REQUEST FOR ADVICE ON SEARS SCOPING REPORT – WOOLWORTHS WAREHOUSE AND DISTRIBUTION CENTRE (SSD-15221509)

This correspondence relates to the Department of Planning Industry and Environments (DPIE) request for advice on the Secretary's Environmental Assessment Requirements (SEARs) Scoping Report prepared by Willow Tree Planning for the proposed warehouse and distribution centre at 250 Victoria Street, Wetherill Park.

**REQUEST FOR SEARS – WOOLWORTHS WAREHOUSE & DISTRIBUTION CENTRE
– 250 VICTORIA ROAD, WETHERILL PARK**

Figure 1 – potential operational and construction truck routes

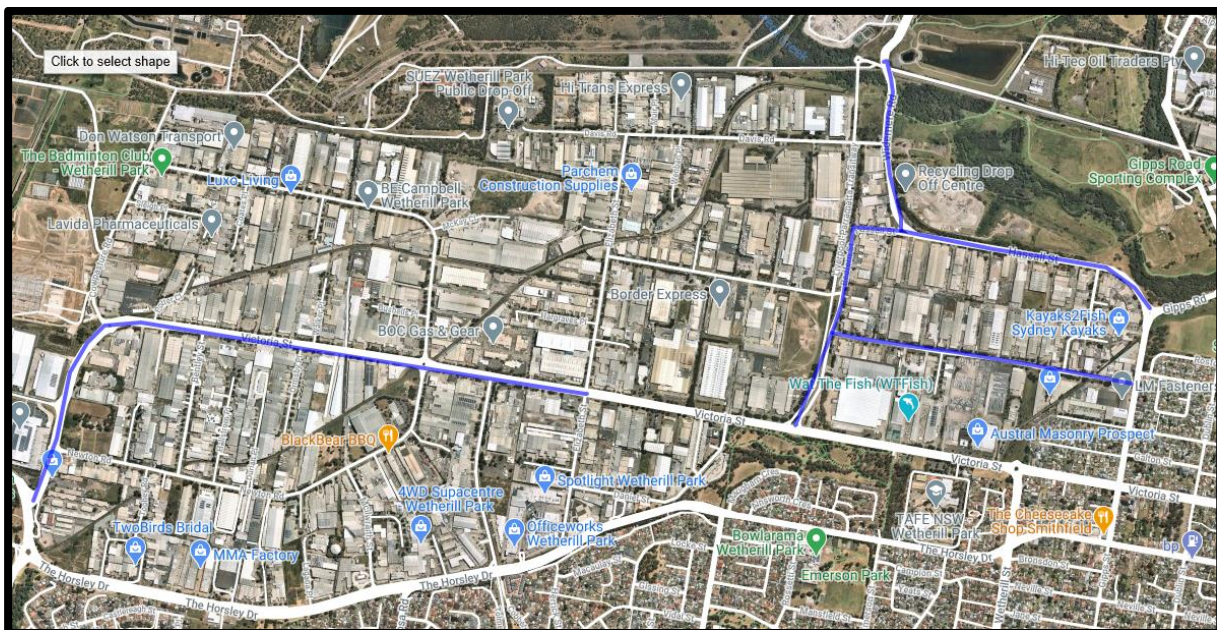
Heavy Vehicle Routes - The EIS must address additional truck routes that have not been addressed in the scoping report, including:

- Redfern Street between Walter Street and Hassall Street;
- Redfern Street between Walter Street and Hassall Street;
- Hassall Street between Redfern Street and Widemere Road;
- Widemere Road between Hassall Street and Council's Boundary;
- Hassall Street between Gipps Road and Widemere Road;
- Walter Street between Victoria Street and Redfern Street;
- Victoria Street between Cowpasture Road Elizabeth Street;
- Cowpasture Road between The Horsley Drive and Victoria Street ,and;

Council's Assets Team require the applicant engage an experienced pavement design engineer to assess the following and provide a report in relation to the impact of the proposal on existing road pavement and existing drainage structures such as stormwater pipes, pits culverts and bridges in the surrounding road network for heavy vehicle movement during the construction phase of the project.

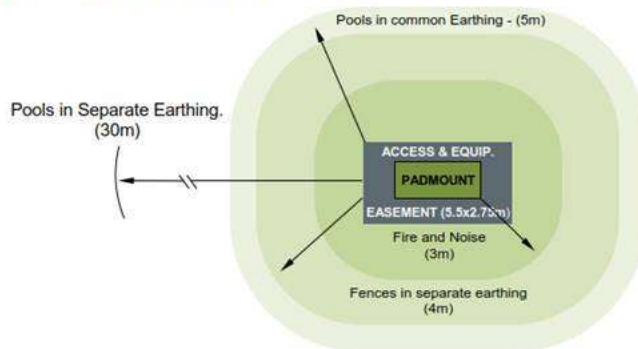
As shown in the below site plan from Endeavour Energy's G/Net master facility model, whilst there are a number of distribution substations in proximity of the site which are likely to have some spare capacity, it would not be sufficient to facilitate the proposed development. As well as the capacity of distribution substations, other factors such as the size and rating / load on the conductors and voltage drop (which can affect the quality of supply particularly with long conductor runs) etc. need to be assessed.

Accordingly an extension and / or augmentation of the existing local network will be required. However the extent of the works will not be determined until the final load assessment is completed. Endeavour Energy's preference is to alert proponents / applicants (and Council) of the potential matters that may arise as further development of areas continues to occur.

In due course the applicant for the proposed development of the site will need to submit an appropriate application based on the maximum demand for electricity for connection of load via Endeavour Energy's Network Connections Branch to carry out the final load assessment and the method of supply will be determined. Straightforward applications can be completed online and permission to connect may be provided immediately if submitting a complying application.
